February 29, 1984 meeting comments: [Crandon Project]. 1984

February 29, 1984 Meeting Comments

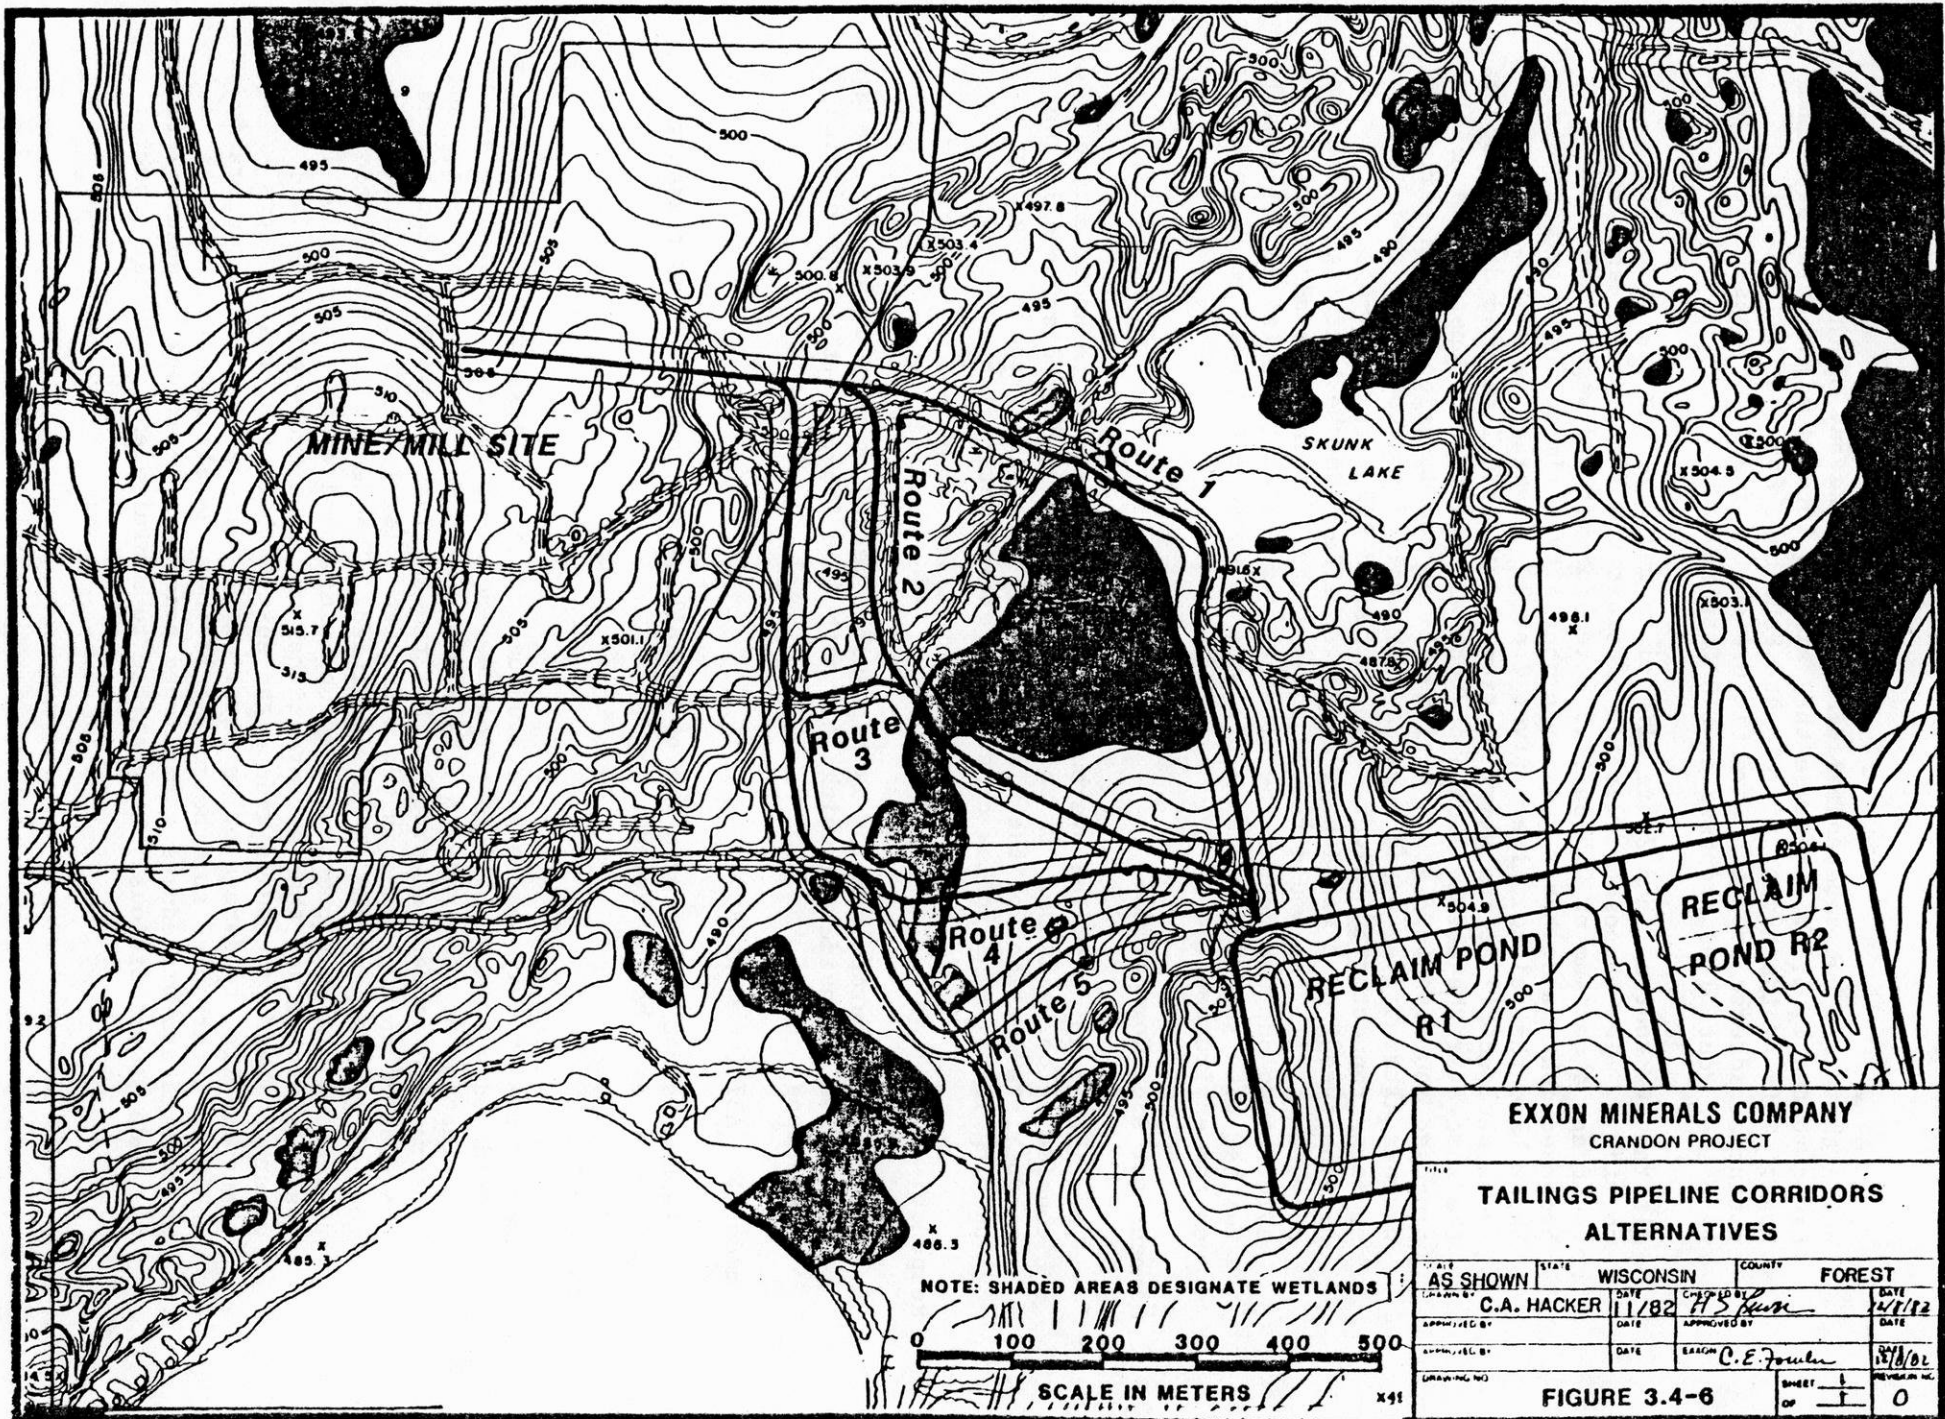
Exxon Minerals Company originally considered four potential routes from the mine/mill site to the MWDF area and a fifth "no-wetlands" alternative was identified in response to an earlier EIR comment No. 10 in the May 11, 1983 DNR letter. All five of the routes are presented in the attached revised Figure 3.4-6.

(Figure for the Response to Comment No. 9)

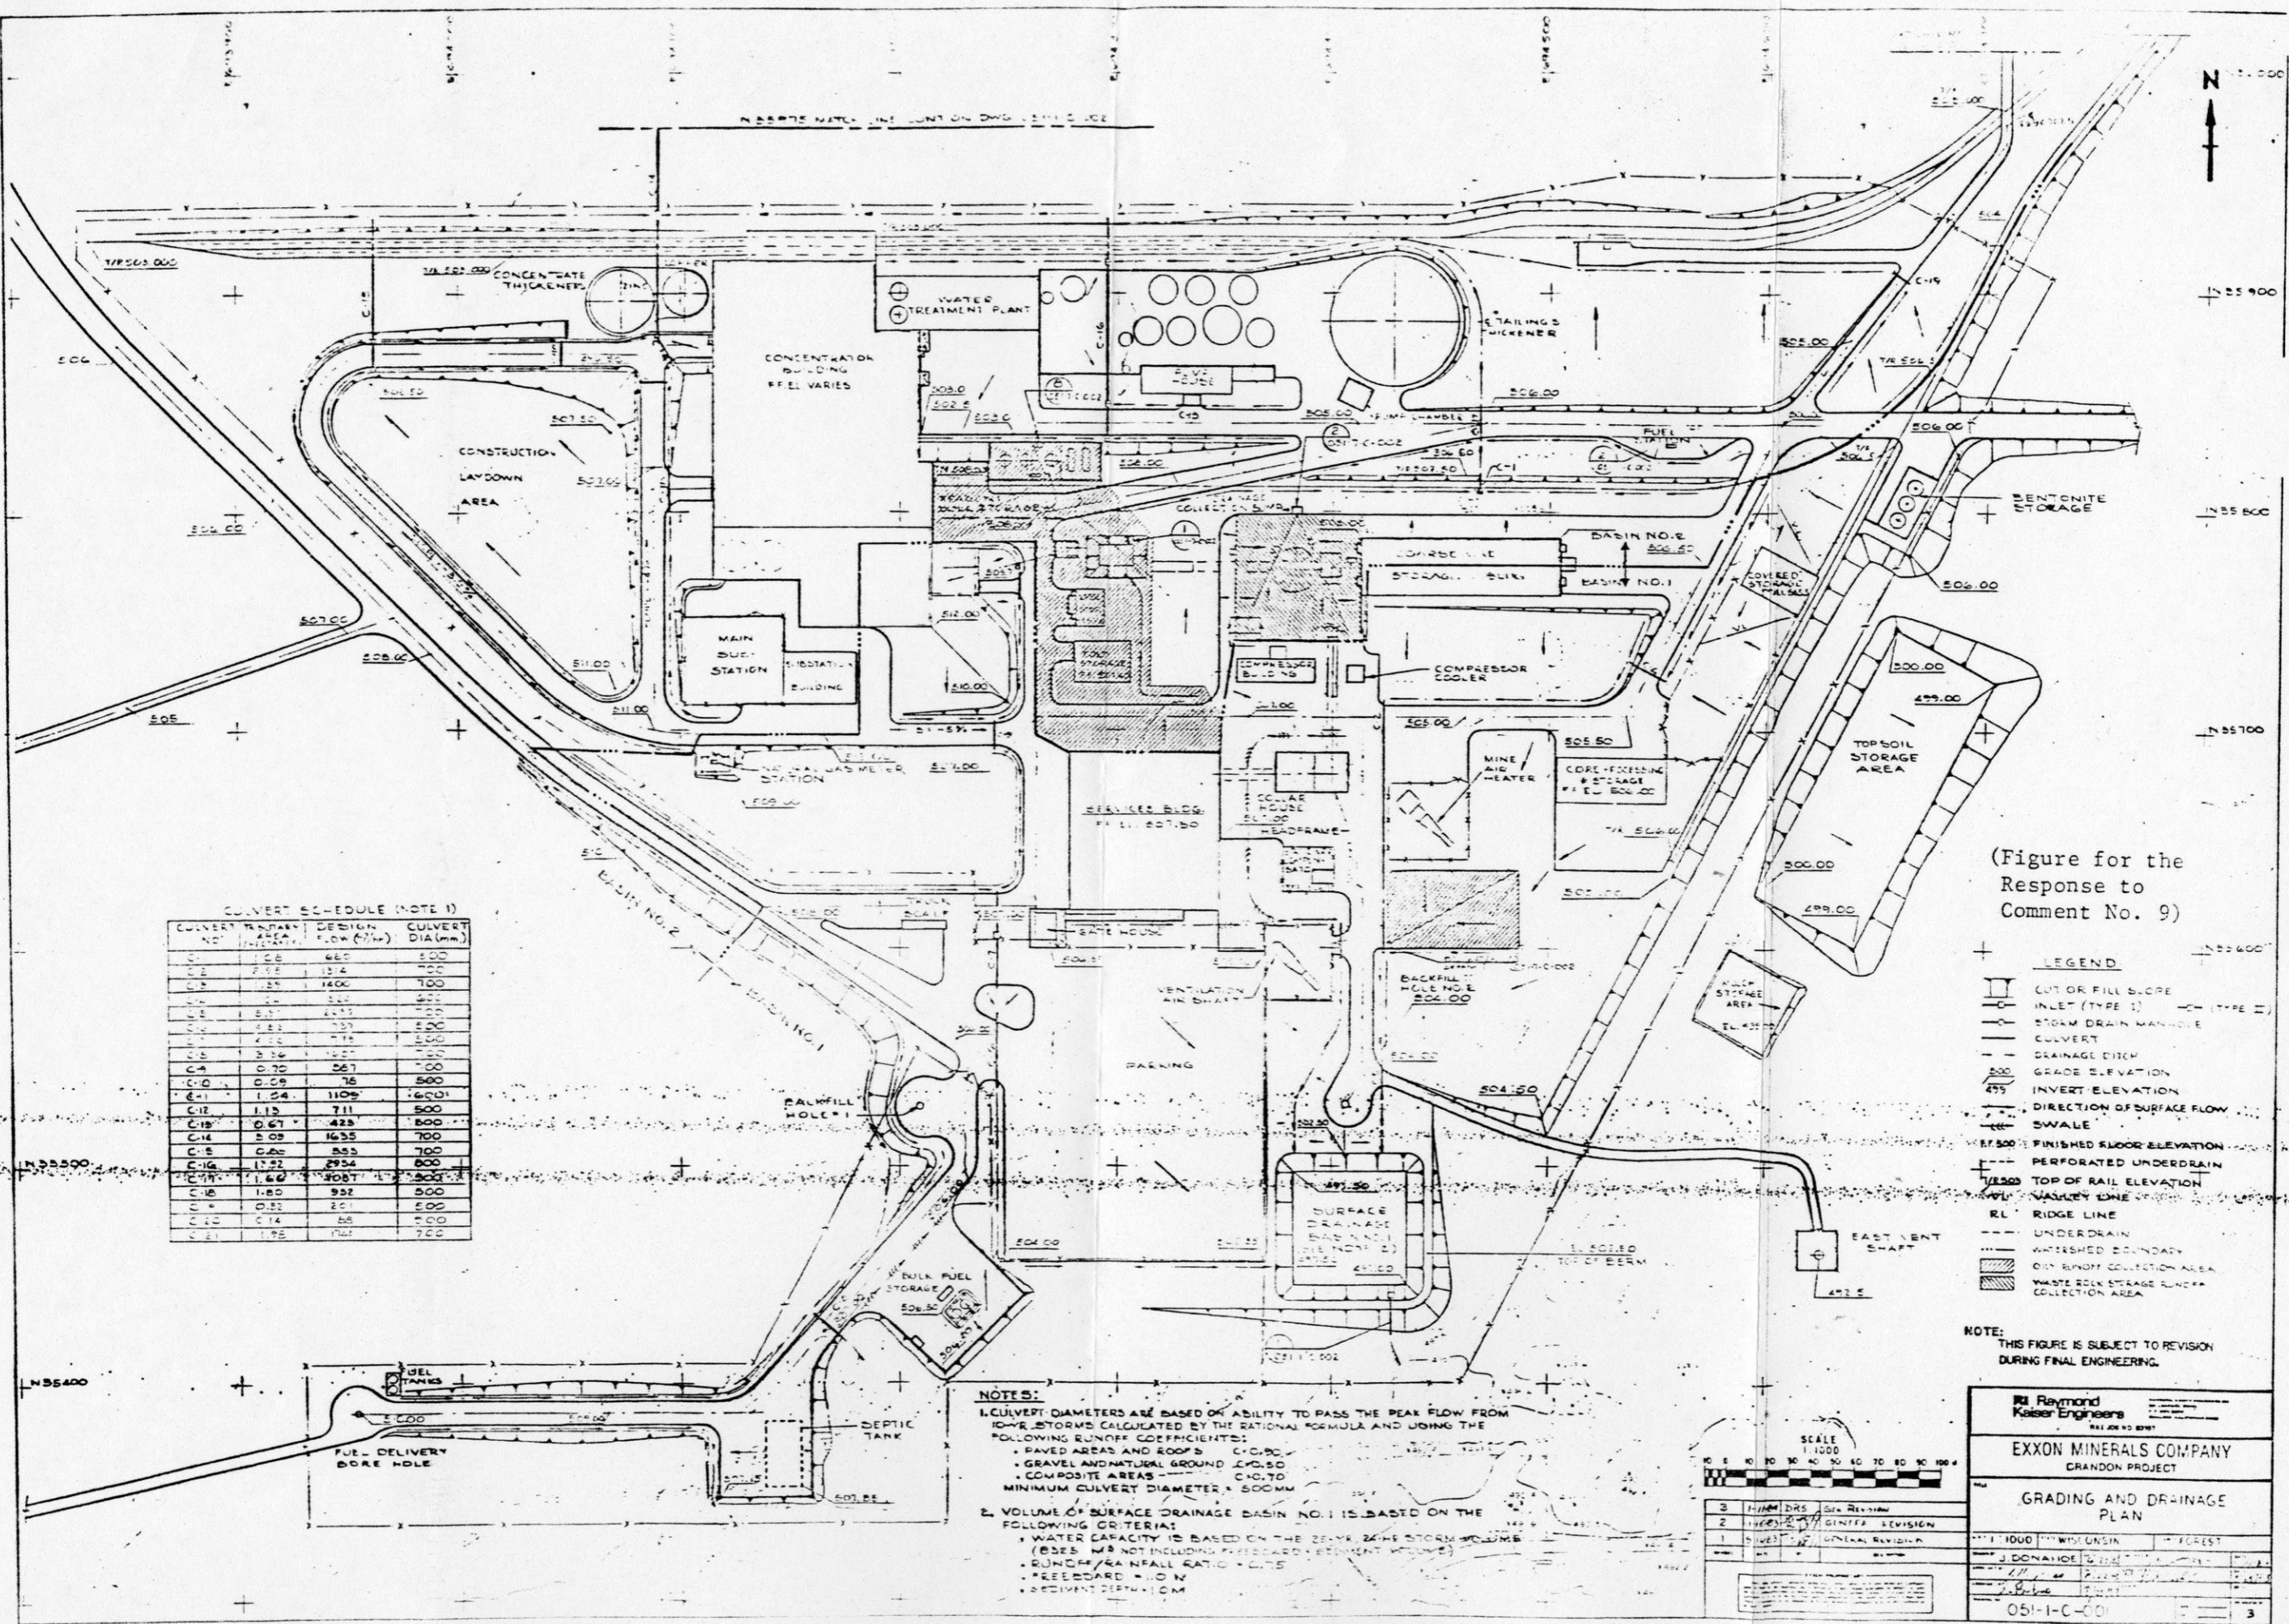
Describe in greater detail the two water retention basins on the site. If basin siltation requires dredging, where will the dredged materials be dumped? Estimate the quality of the water leaving these basins. To which streams will this water flow?

The three attached figures show the current mine/mill site layout, including the locations of the two water drainage basins used for collection, retention, and release of all uncontaminated surface waters in the mine/mill area. Details of the drainage basins and the other surface water drainage facilities, the drainage area for each basin, and the basin sizing criteria are all included on the figures. These figures are subject to revision during final engineering.

(Figure for Response to Comment No. 39)

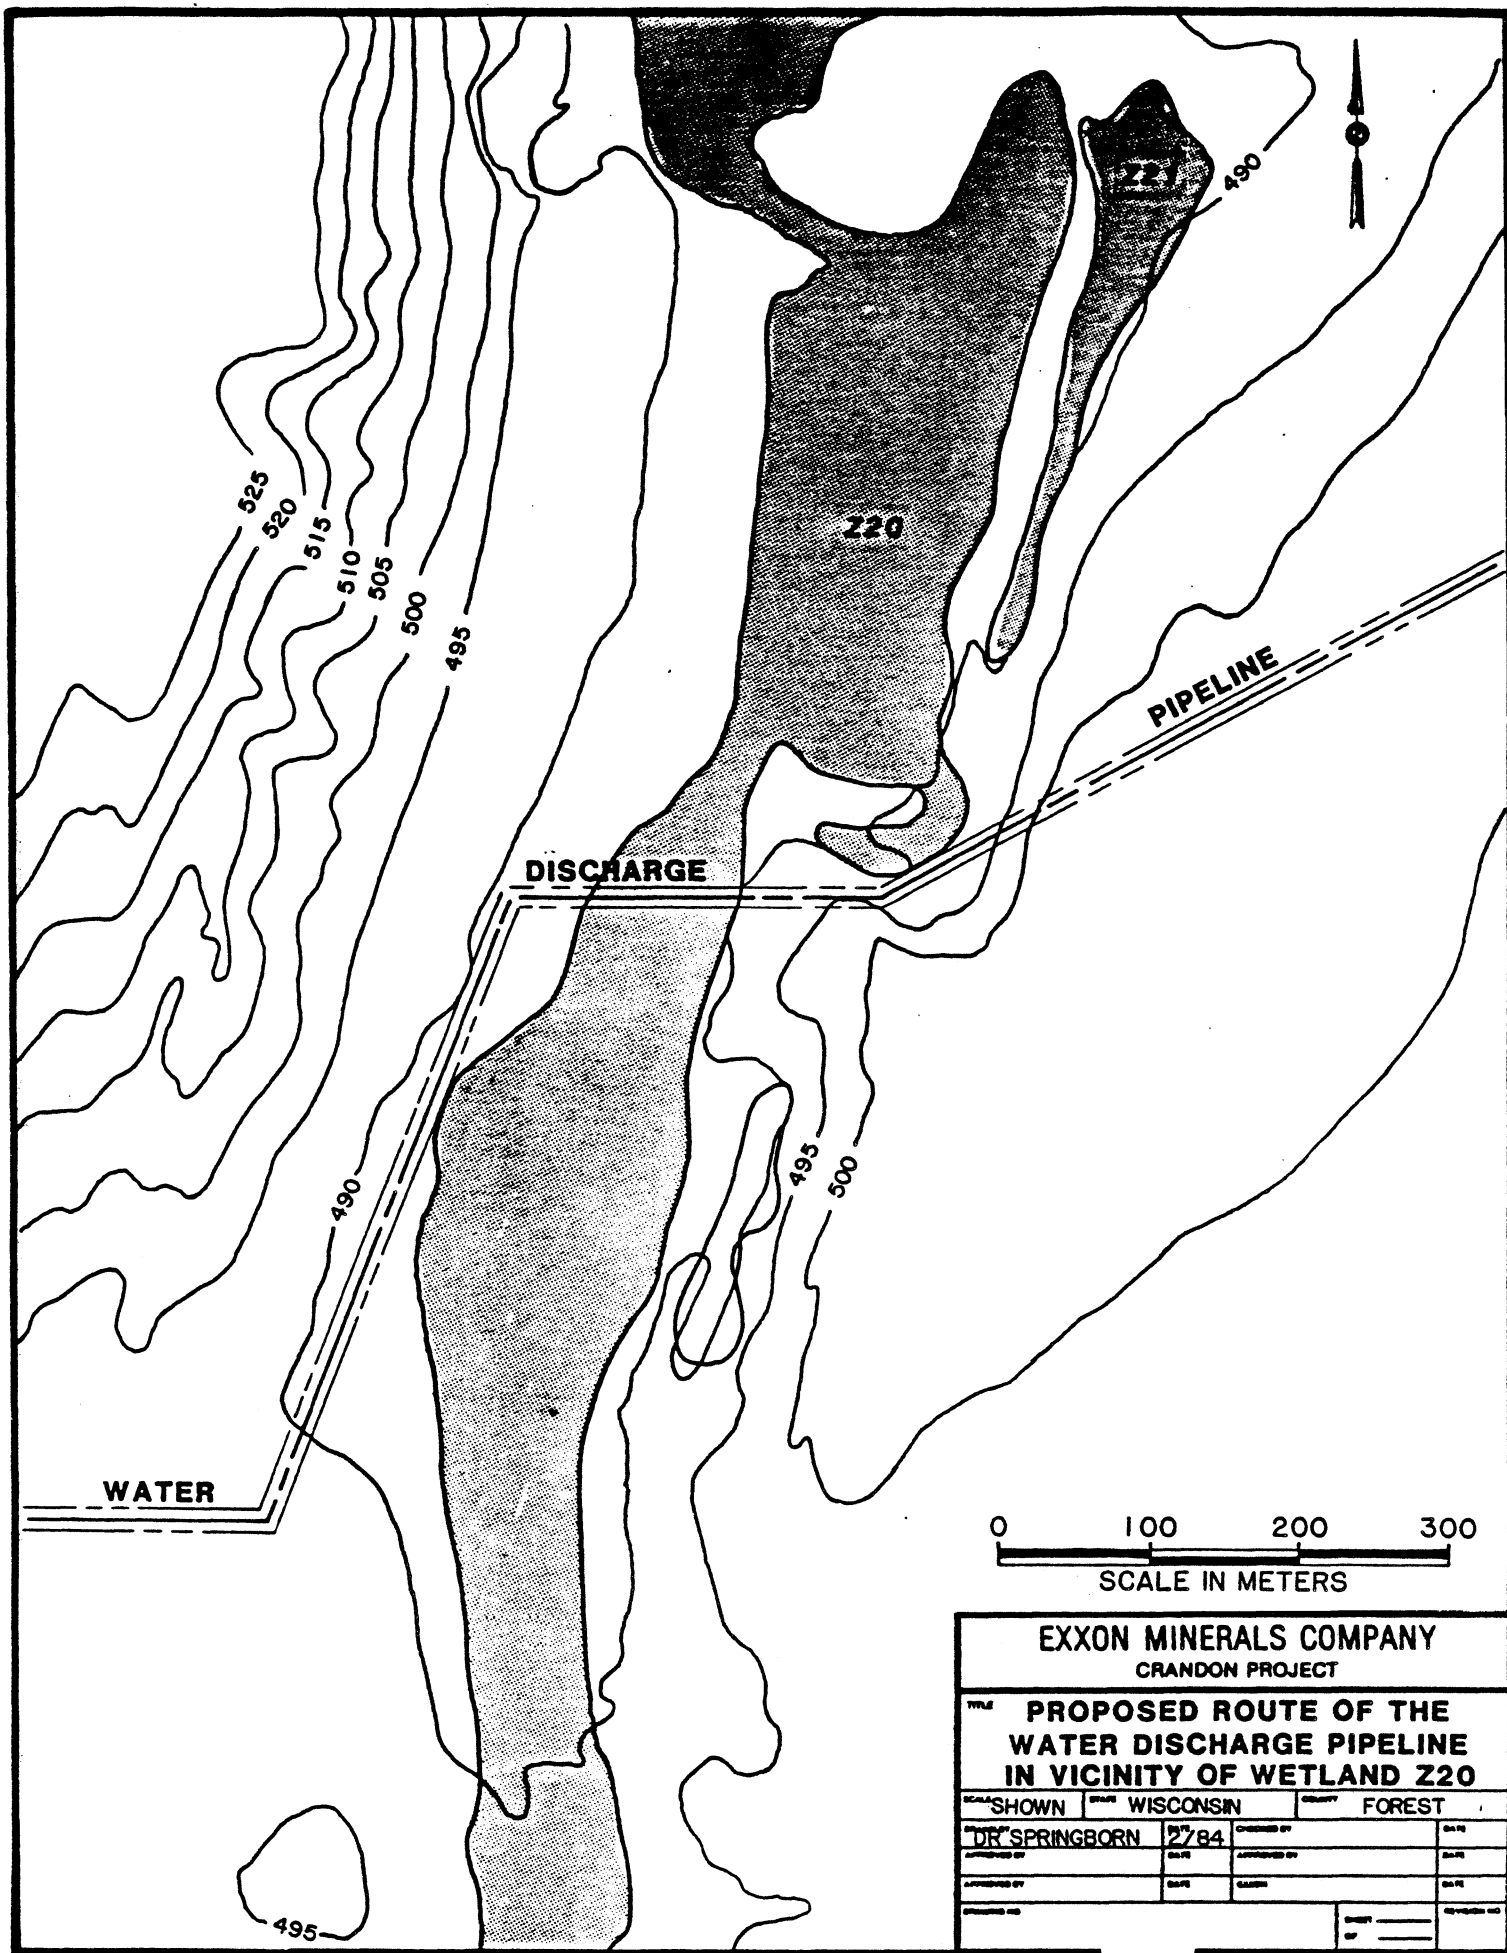
Figure 4.1-13: The discharge pipeline crosses the drainage outlet of Wetland Z-20. The possible effects to this wetland and its outlet from the pipeline construction should be addressed.

The water discharge pipeline will be aligned to minimize impacts to wetland Z20. As shown in the attached figure, the pipeline will be routed so that wetland Z20 is crossed at a narrow point. During construction and installation of the pipeline, less than 0.03 ha (0.09 acre) of wetland Z20 will be affected. To ensure there are no long-term adverse impacts on the hydrologic characteristics of this wetland, as well as other wetlands that may be disturbed during construction of the pipeline, the trench will be backfilled with free draining granular fill materials and the organic soils originally removed during excavation. These materials will allow maintenance of existing surface and subsurface flow conditions through the wetland and there will be no long-term effects on the hydrology of the wetland or its outlet.
